BROADCOM

PCN-314390

Product Change Notice

Change Description:
Introduction of new MEMS die foundry

Current	New

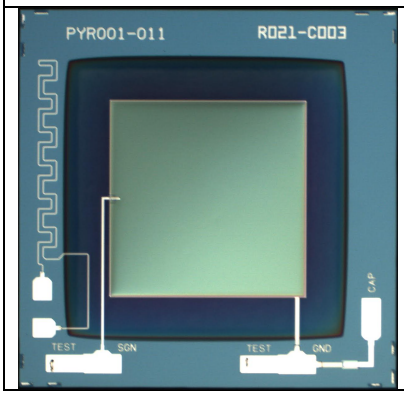
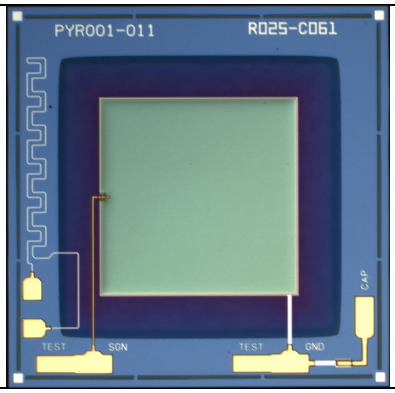
Description and Extent of Change:
We have successfully qualified a new MEMS die foundry with a slightly different die design in addition to our current supplier. The sensitive area of the die and the performance do not change. This change is intended to maintain our strict performance and reliability standards while establishing a more sustainable supply chain.

Effect of Change on Fit, Form, Function, Quality, or Reliability:
There is no change in the dimensions of the die, but the design of the die itself was slightly changed. To ensure optimum performance and reliability, appropriate qualification tests have been successfully performed.
